**PETERSON BOULEVARD & SPACE VILLAGE AVENUE
COLORADO SPRINGS, CO**

TRAFFIC IMPACT STUDY

PROJECT NO. 017-1754

dsdlaforce (11)

FIGURE 2

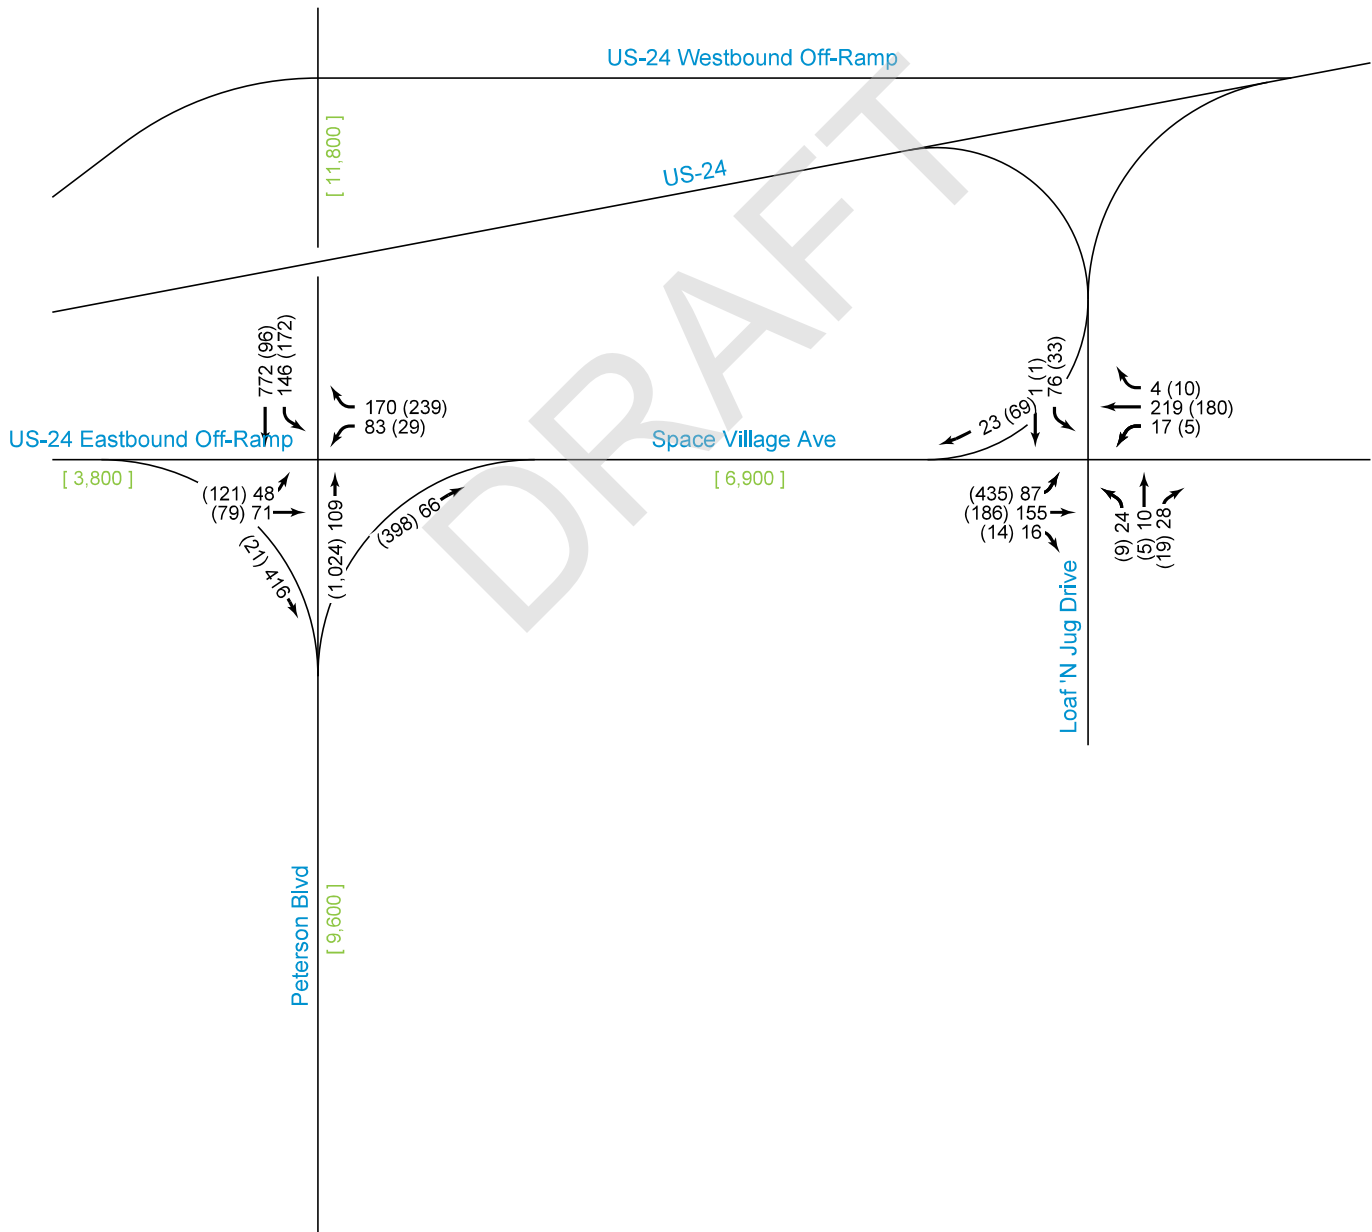
With this area involving multiple jurisdictions, for clarification identify (via narrative and/or exhibit) which jurisdiction owns/maintains which road.

FIGURE 4

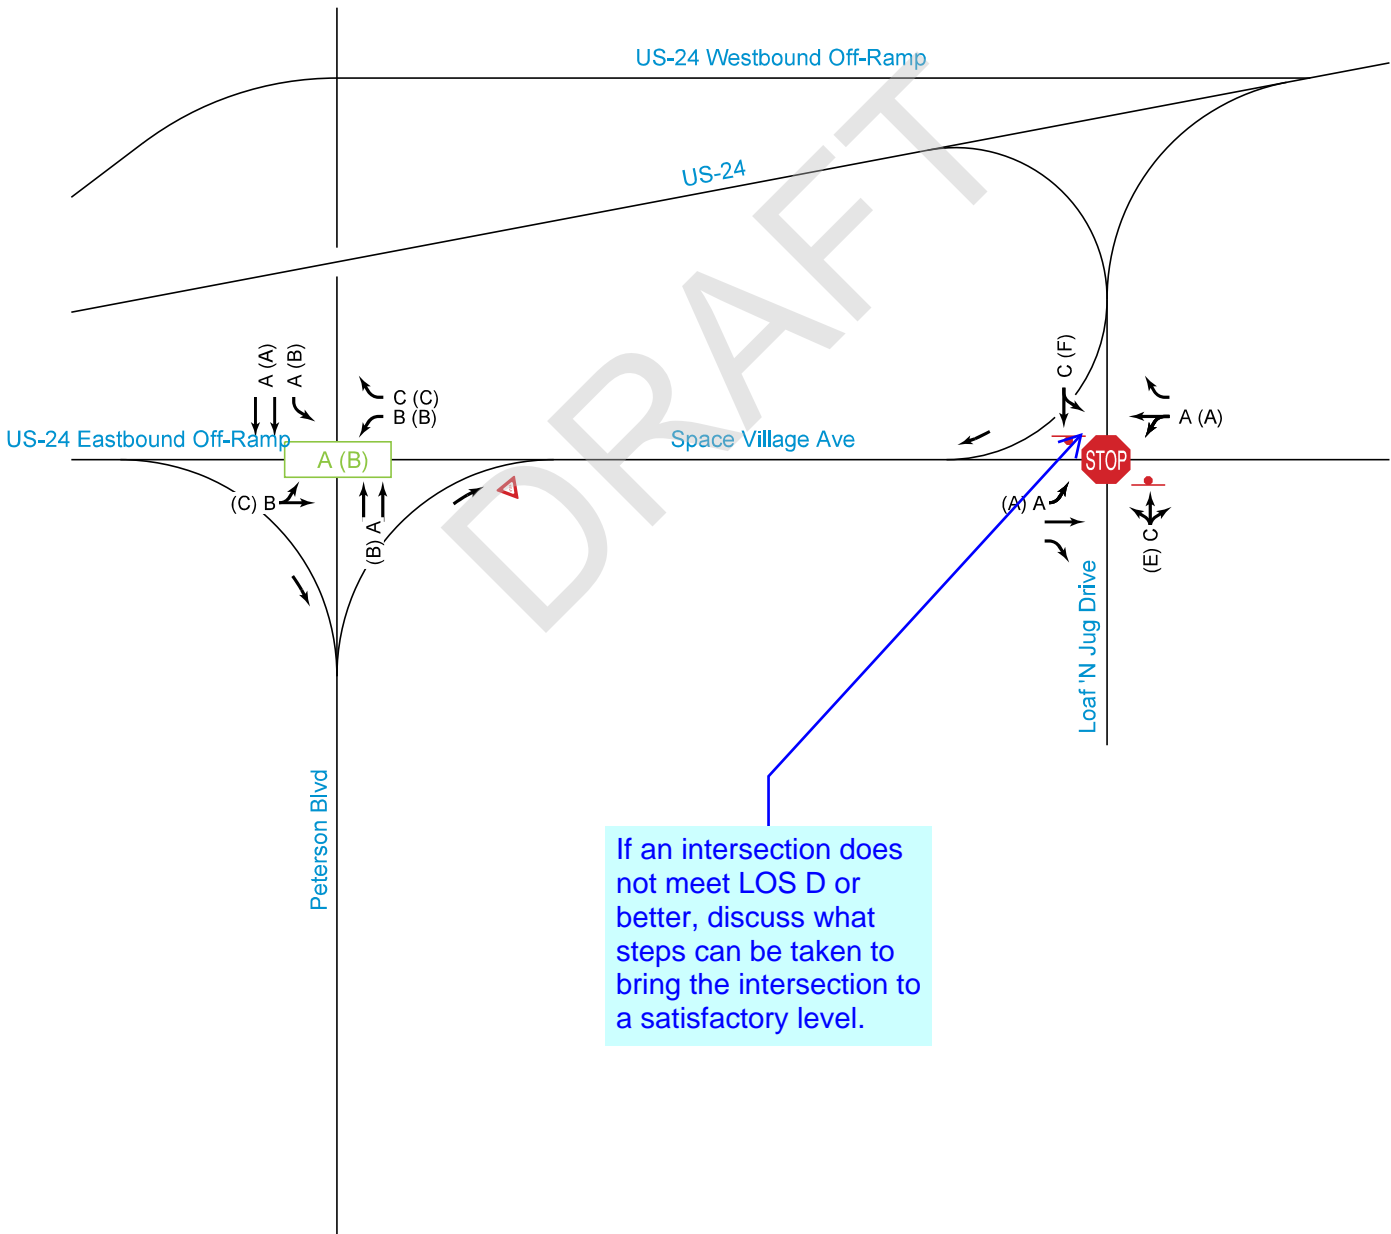
If an intersection does not meet LOS D or better, discuss what steps can be taken to bring the intersection to a satisfactory level.
